Review of the inputs of Professor David Smythe in relation to planning applications for shale gas development in Lancashire (planning applications LCC/2014/0096 /0097 /0101 and /0102) and associated recommendations

Professor Paul L. Younger FEng
and

Dr Rob Westaway
School of Engineering, University of Glasgow, Glasgow G12 8QQ.

17 December 2014

Fig. 1. Cross-section illustrating the geometry of the faulting in the vicinity of the Preston New Road site, from Fig. 6 of Appendix L of planning application /0096

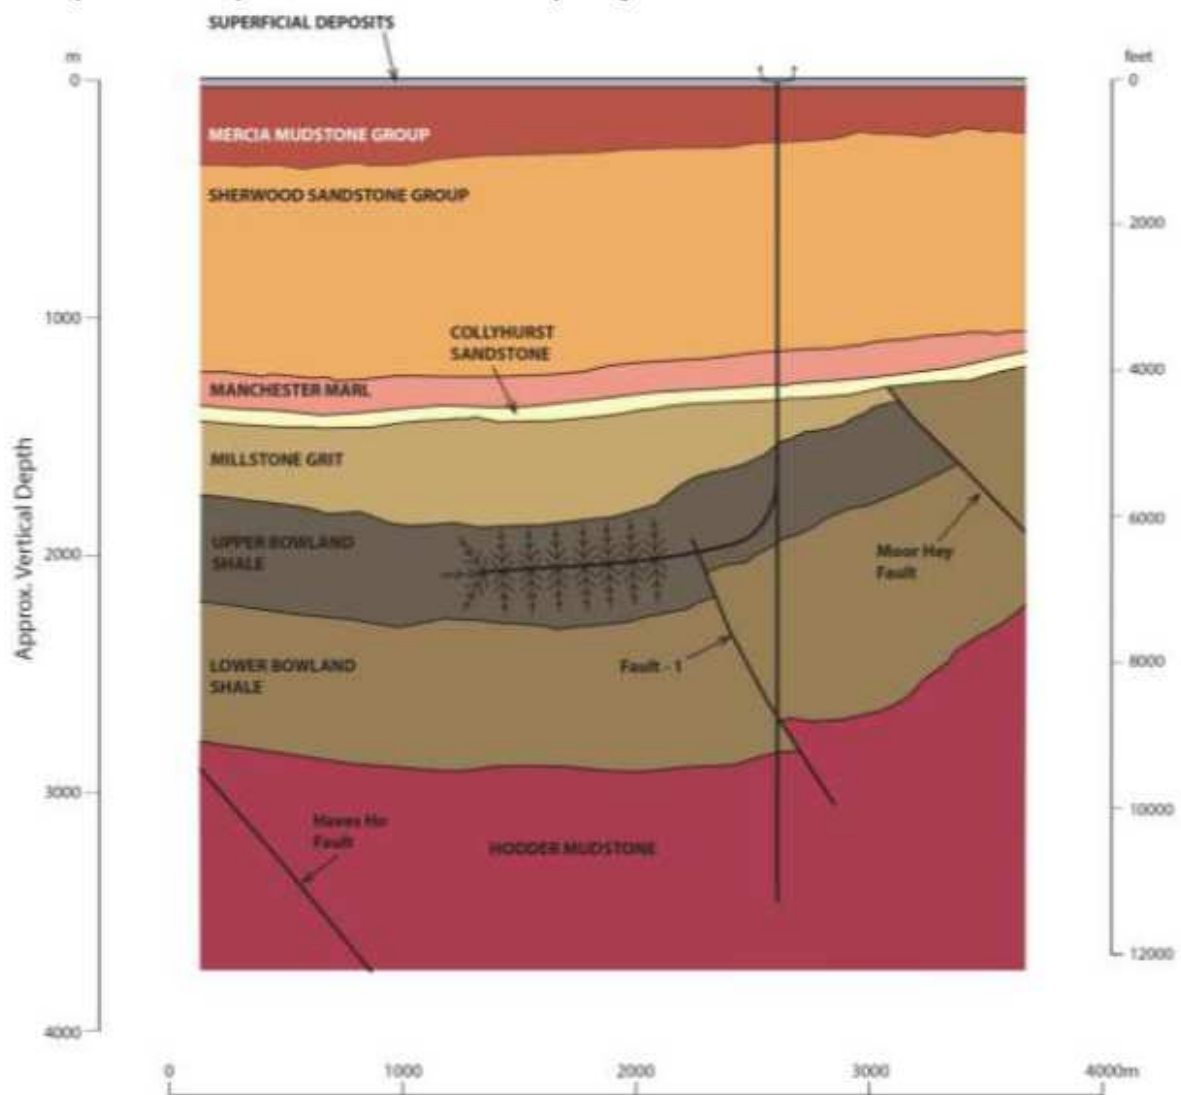
The first of these aspects is trivial; although the planning applications include schematic maps that do not show every detail, elsewhere (in other documents submitted, including some of the illustrative material that Professor Smythe used in his submission) Cuadrilla also included definitive geological maps or cross sections, based on the most up to date geological background information, which show all the faults that are known (or interpreted) in the area. For example, the faulting interpreted in the vicinity of the Preston New Road site is illustrated in Fig. 1 and that in the vicinity of the Roseacre Wood site in Fig. 2. Indeed, Professor Smythe's depiction of the faults in Fig. 3 does not differ significantly from the depictions by Cuadrilla in Figs 1 and 2; the depiction of the same faults in the recent BGS / DECC Bowland Basin shale gas report (Fig. 4) is, likewise, very similar. Professor Smythe also makes much of an undocumented assertion (on p. 3 of both 'objection' documents) that **"...the density of faulting in the Weald, the Bowland Basin and the Midland Valley (Scotland) is 400 times greater, as measured by length of surface fault trace per unit area, than the average for the US shale gas and shale oil basins ..."**. There are three points to be made in relation to this:

The last of Professor Smythe's issues, that some of the fault interpretation by Cuadrilla may well be incorrect, also has no significant consequences. He has argued that the interpretation of Fault 1 in Fig. 1 makes no sense and that this fault more likely continues upward through the Bowland Shale and the overlying Millstone Grit, dying out at the unconformity between that and the younger sediments above. He is probably correct about this; at any locality in northern England (see De Paola et al., 2005, and others) the most likely timing of reverse slip such as this is during the Variscan orogeny (i.e., ~300 million years ago), after the Millstone Grit was emplaced but before the younger deposits were laid down. This means that the vertical extent of this fault should be estimated as ~1.8 km rather than the ~1.3 km indicated by Cuadrilla. However, whether it is ~1.3 km or ~1.8 km, it is still an important fault with implications for the hazard of undertaking the project in this area.

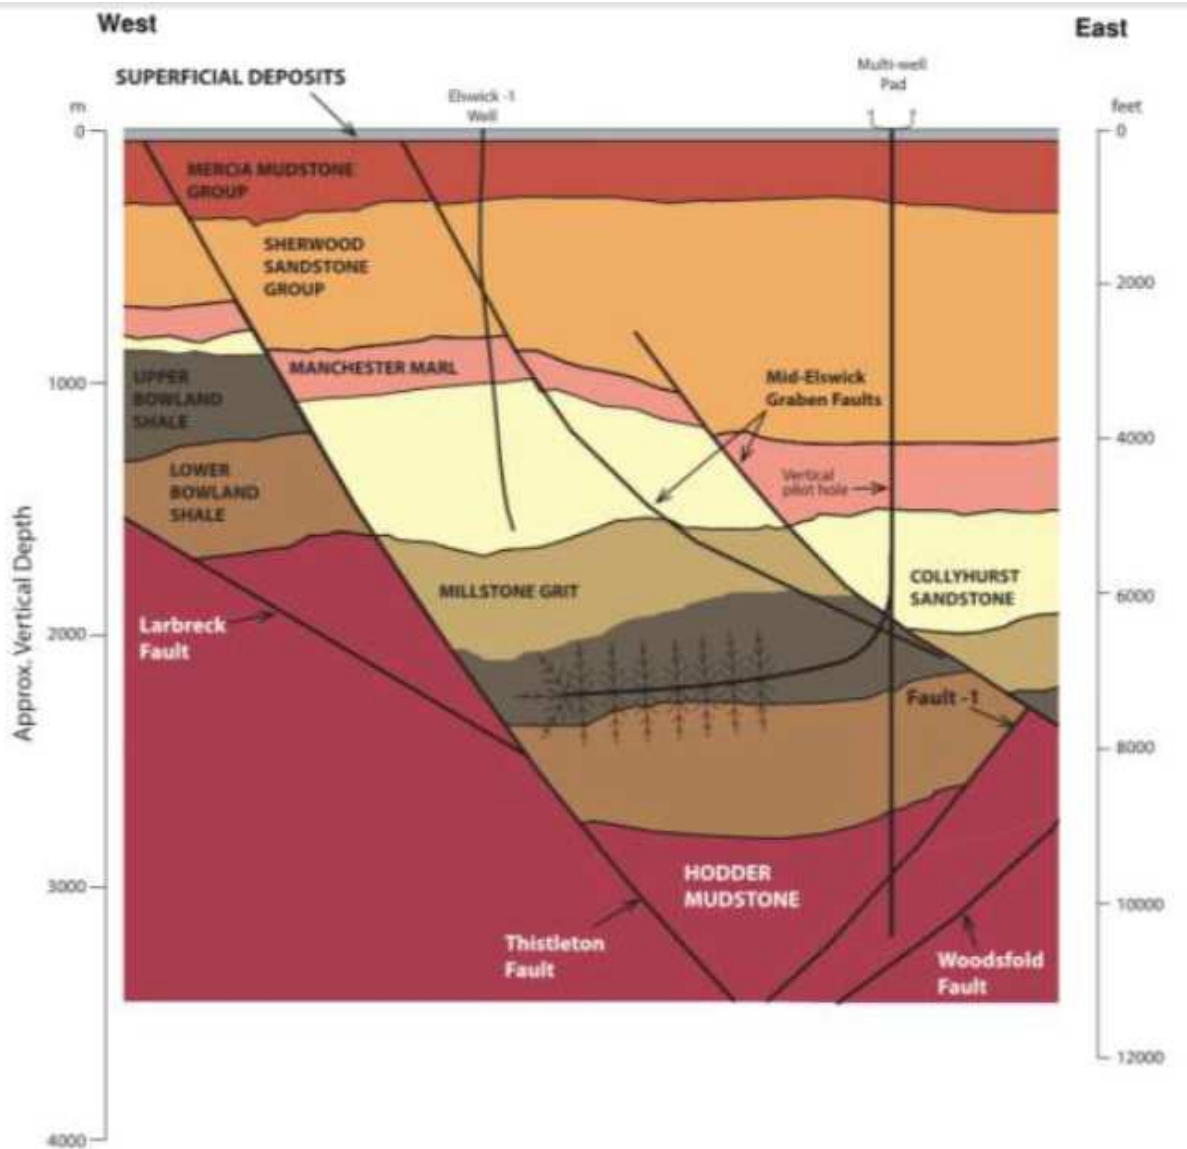
Of greater potential significance to the present planning applications is the second type of induced earthquake, involving the lubrication by fracking fluid of pre-existing faults. It is apparent that the proposed fracking operations are planned to occur within ~100 m of important faults (Figs. 1 and 2). Professor Smythe has written '**Cuadrilla has defined so-called 'regional' faults, which will be avoided by the fracking operations, and 'local' faults, through which drilling and fracking may take place. Its definitions are inconsistent and illogical. All faults should be avoided, whatever the scale; if this results in the Bowland Basin being unexploitable for shale gas, then so be it.**' Cuadrilla thus regard the Woodsfold Fault depicted in Fig. 2 as 'regional' and so to be avoided; thus the Roseacre Wood site has been chosen to be more than a kilometre away from it (Fig. 2). However, Professor Smythe is entirely correct to note the illogicality of attaching less importance to the other faults, from the point of view of induced seismicity, when they are of sufficient size to rupture in damaging earthquakes. We nonetheless consider his second sentence to be itself illogical: faults should be avoided IF they are large enough to slip in damaging earthquakes and IF the effects of fracking have a demonstrable likelihood of bringing the fault to the condition for shear failure.

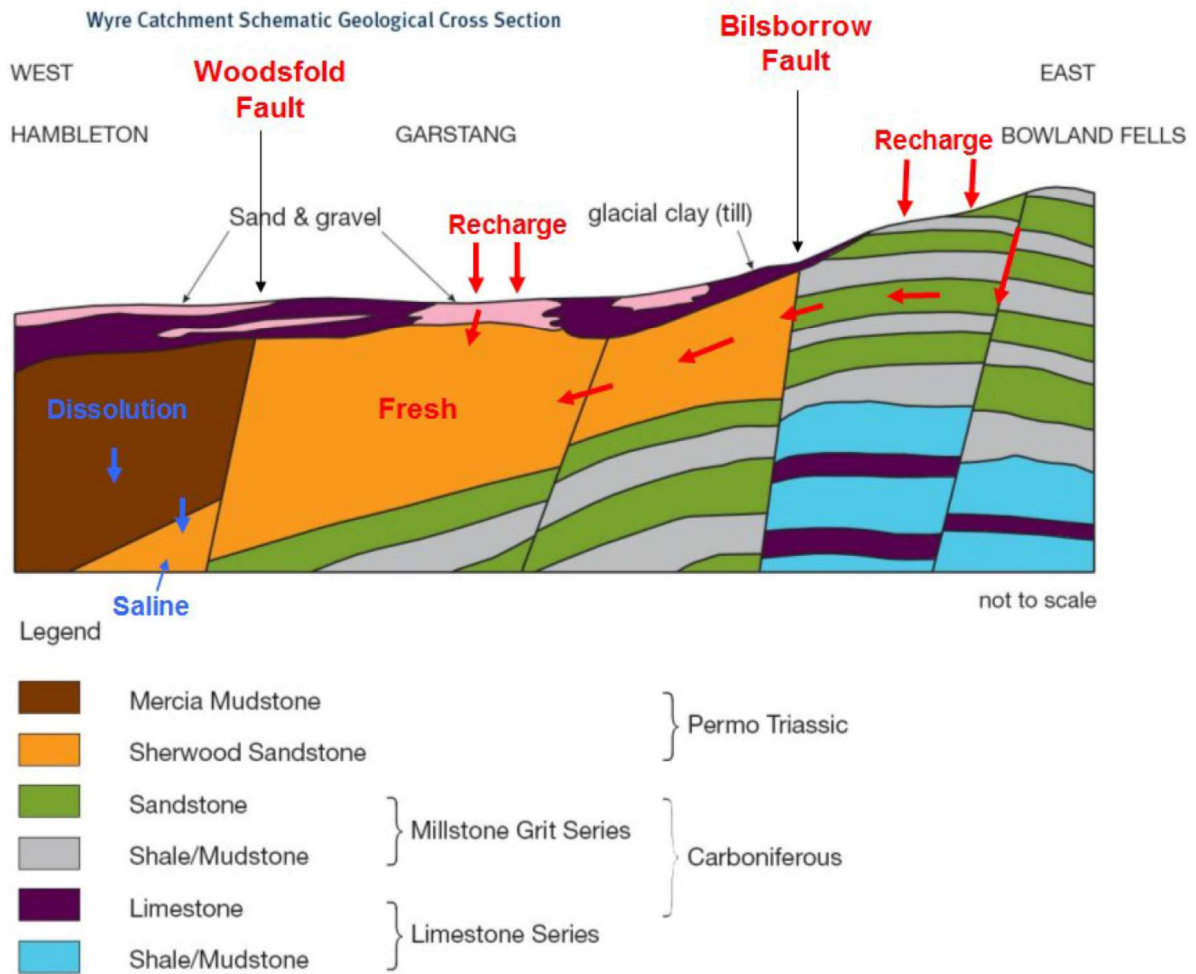
As regards the third issue, groundwater / surface water pollution risks, Professor Smythe has claimed that **'The hydrogeology of the area immediately east of the site shows that regional faults are transmissive.'** The annotated version of an Environment Agency cross-section relating to the Sherwood Sandstone Group is presented and discussed by Professor Smythe, and is repeated here as Fig. 3. The argument he is basing upon this diagram is nowhere explained in detail, but it would appear that the point he is attempting to make is that, if the Woodsfold Fault is transmissive where it cuts sandstones, faults must also be permeable where they cut the Bowland Shale at greater depth. Professor Smythe thus considers that all geological faults should be regarded as leaky unless proved otherwise. He implies that this is the standard assumption made in hydrogeological investigations. However, this is not so. There are at least three issues here which Professor Smythe fails to consider:

- (i) Where faults cut low-permeability strata such as shale (and even locally where the fault passes from a shale into a more permeable bed) there is a marked tendency for the fault plane to be lined with a fine-grained clay-rich material known as "fault gouge", which typically renders these portions of the fault planes effectively impermeable (e.g., Younger 2007). In contrast, where the same fault cuts a permeable rock such as sandstone (and the displacement has not smeared clay-rich gouge from an over- or under-lying mudstone into the fault zone, then the fault plane may well be occupied by relatively permeable breccia; minor fractures either side of the fault plane in a sandstone might also be relatively clean and open. This explains where the faults cut sandstones in the recharge area described by Professor Smythe (Fig. 3) they are believed to be permeable. HOWEVER, because of the formation of fault gouge where the same faults pass down into mudstones, there is no *a priori* reason to suppose that these faults are permeable throughout their depths: where they cut mudstones they are overwhelmingly likely to be of low permeability.

- (ii) Even where a fault is not so lined with gouge as to render it impermeable, it is subject to the present crustal stress regime, which tends to favour faults being more permeable where they are aligned fairly closely to the current maximum compressive stress azimuth, but tends to

make them far less permeable if they are otherwise oriented (e.g., Ellis *et al.* 2014). Note that this does not override the basic permeability control provided by fault gouge.

- (iii) Crucially, even where a fault is continuously permeable over a large vertical interval (which is unlikely in sequences, like those in the region under consideration, that contain thick mudstones) groundwater flow can only occur if there is a sustained driving head from one area to another. There is no evidence of any such upward-oriented hydraulic gradient in this region, and the extremely short-lived pulses of increased head close to the boreholes during fracking operations are insufficient to overcome the head in overlying strata. Where conventional oil and gas reservoirs occur, natural upward hydraulic gradients may exist, but oil and gas only accumulate where permeable pathways upwards are insufficient to allow dissipation of fluid pressure over geological time. It is inherent in the very definition of UNCONVENTIONAL gas that such over-pressure does not occur – hence the need for reservoir stimulation and depressurisation of the target horizon in order to get gas to move into boreholes. These points were addressed in the Joint Royal Academies’ report (Mair *et al.* 2012), although Professor Smythe seems to have overlooked this.

It is for the above reasons that the actual consensus amongst hydrogeologists is that faults are *not* everywhere to be assumed to be permeable, let alone pathways for upwards migration of water in the absence of a driving head. Rather, faults are hydrogeologically ambiguous: the same fault can be impermeable where it passes through mudstone, and locally permeable where it cuts sandstones – provided of course it is oriented appropriately vis-a-vis the present crustal stress regime. In neglecting the above factors, Professor Smythe has failed to account properly for the most likely hydrogeological behaviour of the faults in the areas considered, at least as regards the overwhelming likelihood that they will be of very low permeability where they pass through the Bowland Shales. For this reason, the alarming scenarios of pollution of shallow groundwater and surface waters due to fracking operations, as suggested by Professor Smythe, are not credible. Consideration of fault permeability is also relevant to the decision by Cuadrilla to not attempt to propose drilling or fracking near the Woodsfold Fault but to propose these activities near other faults: the Woodsfold Fault has such great displacement that it offsets the impermeable Bowland Shale and juxtaposes potentially permeable rocks against it (Fig. 4), whereas the other faults have much smaller displacements and thus juxtapose Bowland Shale against Bowland Shale. In this respect, the Woodsfold Fault may well be hydrogeologically different from the others in the area. Professor Smythe moves on to suggest the drilling of several 1 km-deep boreholes to characterise the hydrogeology of the Woodsfold Fault, even though the planning applications specifically state that the projects are designed to avoid this particular fault. If his assertion that this fault plane is permeable is actually correct, drilling boreholes through it would introduce potential flowpaths where none currently exist; it might thus alter the pressure of groundwater within this fault in a manner that might affect the state of stress so as to make the conditions more conducive to this fault (or part of it) slipping in a future earthquake. Setting aside the expense of drilling such boreholes, this is therefore a foolish suggestion and demonstrates a lack of knowledge on the part of Professor Smythe. Although he has evidently not considered why the Woodsfold Fault should be regarded, from the point of view of hydrogeology, as different from the others, it should be noted that this aspect could have been explained much more clearly by Cuadrilla in the first place.

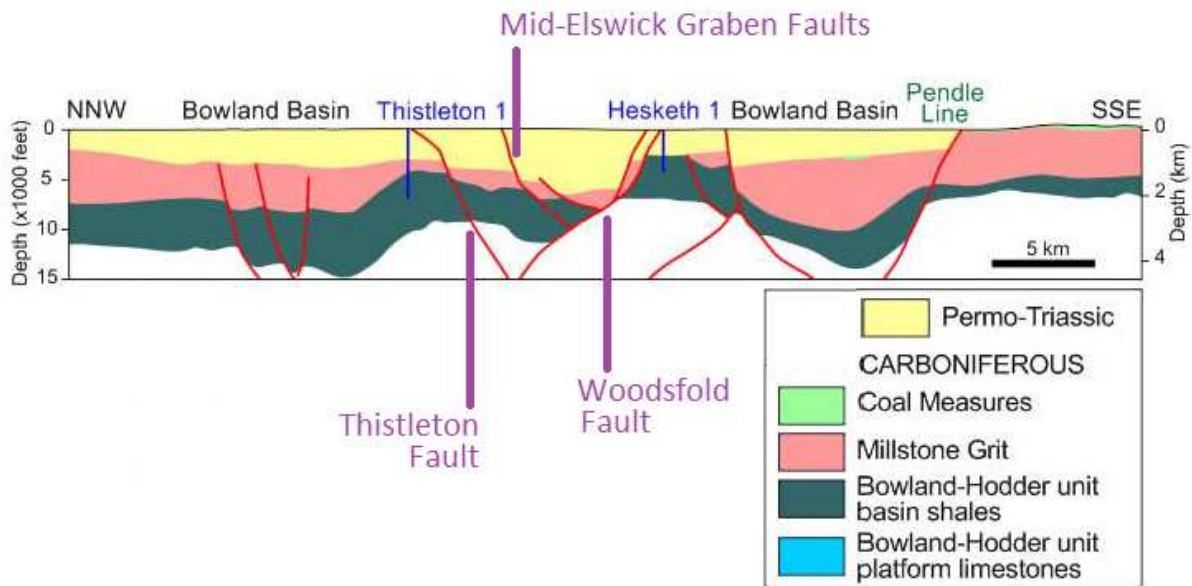
The second of Professor Smythe’s points, however, is of the utmost importance. In principle, as a worst-case scenario, the possibility exists that during fracking operations at the proposed sites, fracking fluid will leak into the faults depicted (such as Fault 1 in Fig. 1 or the ‘Mid-Elswick Graben Faults, Thistleton Fault, or Larbreck Fault in Fig. 2), because this fluid might flow to these faults through the network of new fractures created in the Bowland Shale by the fracking, notwithstanding the low permeability of the unfractured Bowland Shale (see above). In principle, the presence of this fluid might then lubricate any part of any of these faults that it reaches sufficiently to bring it to the

condition for shear failure, potentially resulting in an earthquake. If so, the resulting earthquake might (again, as a worst-case scenario) rupture the entire area of the fault; thus, since the faults depicted are all >1 km in vertical extent and at least several km long, the fault areas are many square kilometres, so earthquakes of the order of magnitude 5, at least, might thus occur. Earthquakes of this size would be readily large enough to cause damage to property and might well result in injuries or even fatalities, for example from falling masonry (e.g., falling chimneys collapsing onto victims). It is essential, therefore, to demonstrate that the design of the proposed projects precludes the possibility of any such eventuality.

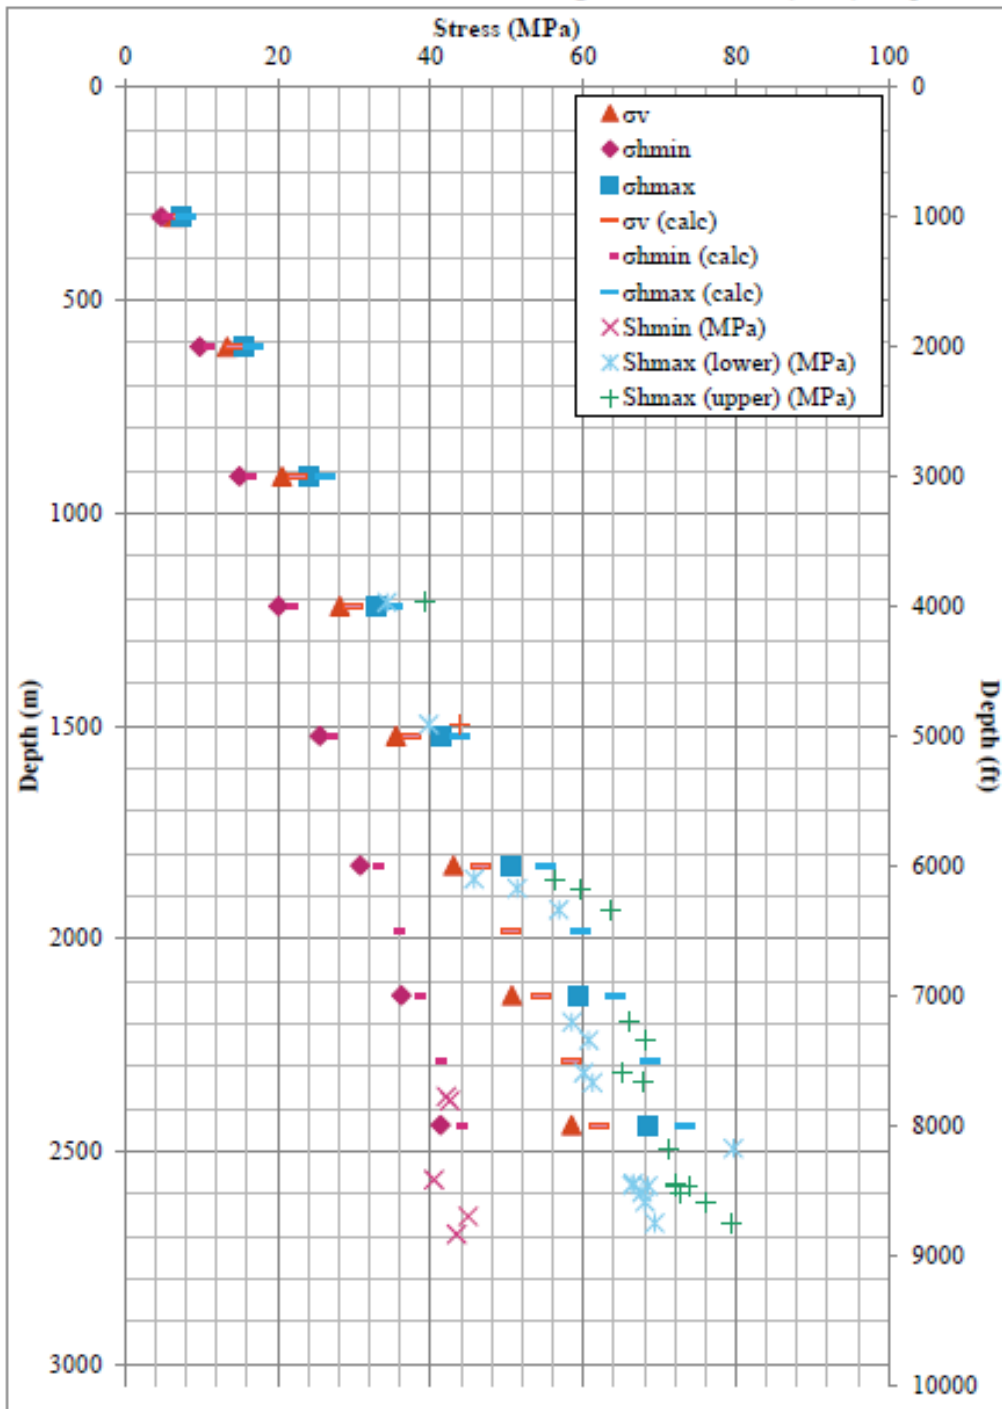
In their Appendix L documents for both planning applications Cuadrilla repeatedly mention mitigation measures but the essential point is that they state that the orientation and magnitude of the local stress field will be measured during the vertical drilling phase and will inform the applications for permission to subsequently begin fracking operations. This is stated on p. 45 of Appendix L of the Preston New Road planning application and p. 46 of Appendix L of the Roseacre Wood planning

application. On subsequent pages the documents disclose measurements of the state of stress at the Preese Hall 1 borehole (Fig. 5), which Cuadrilla consider representative of the proposed drilling sites. This is a reasonable starting assumption. Cuadrilla also propose to make multiple in situ stress measurements in their proposed boreholes, if these go ahead, during their initial vertical drilling phases, which is also a valid strategy. However, they then say that they will present the resulting data to DECC as part of making the case for being allowed to initiate fracking in these boreholes. This is not satisfactory; first, they do not present any calculations to demonstrate that the proposed projects are safe on the basis of existing stress measurements and plans. Second, it should be apparent that there is no-one at DECC with sufficient expertise to assess this type of technical argument, and since officials at DECC are open to political pressure, there is the possibility of interference in the decision. The correct time to present such a safety case is in the planning application; this is done below, where it is demonstrated that the proposed projects are safe provided the pressure used for the fracking is kept to the minimum necessary. Rather than being examined by DECC, a better strategy for examination of safety plans such as this is to make use of the expertise of academics, who include people with the most relevant skills and experience.

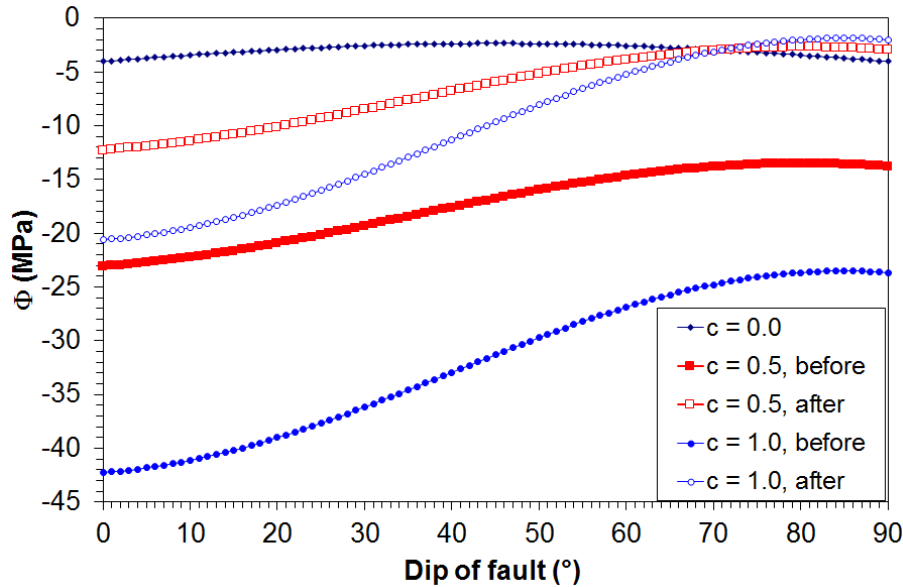
Figure 6 shows that for all conditions considered, the calculations indicate that the proposed project is safe; for no combination of fault orientation and coefficient of friction does Φ rise to zero.

Fig. 7. Alternative solutions for which the fracking fluid is assumed to be at a pressure 5 MPa higher than was assumed for the calculations for Fig. 6.

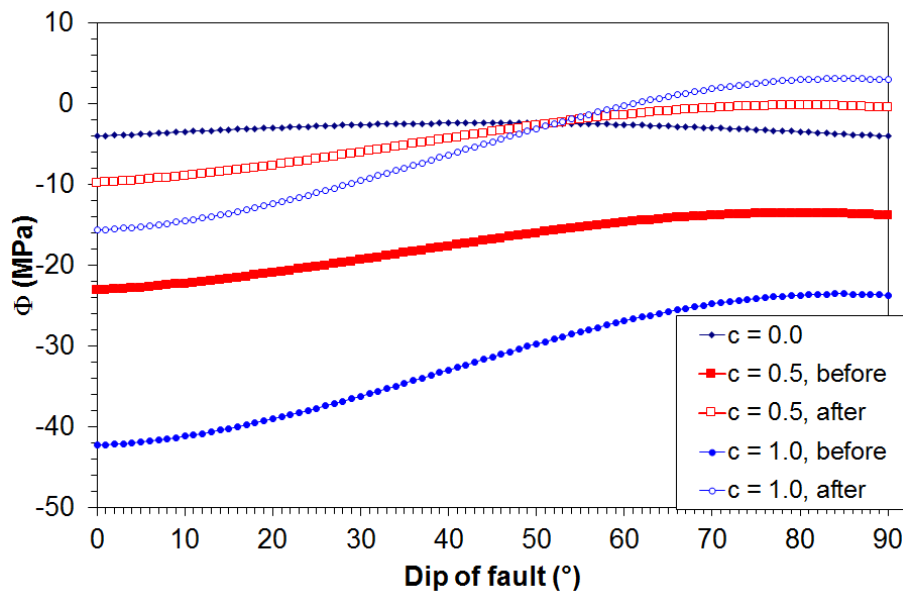
However, Fig. 7 shows an alternative set of calculations, in which it is assumed that the fracking fluid is at a pressure 5 MPa higher than for the previous set of solutions. In this case, it is predicted that Φ can exceed 0 for $c=1.0$ provided the fault dip is 61° or steeper. Since the Thistleton Fault is steeper than this (Fig. 2), this set of conditions might well result in an induced earthquake on this fault. The implication of this analysis is that for the project to be safe, Cuadrilla must be required to limit the pressure of the fracking fluid used in their fracking operations.

- The above-mentioned analysis will result in the determination of the maximum pressure of the fracking fluid that can be considered 'safe' for these projects. Cuadrilla could then be required to adhere to this limit.
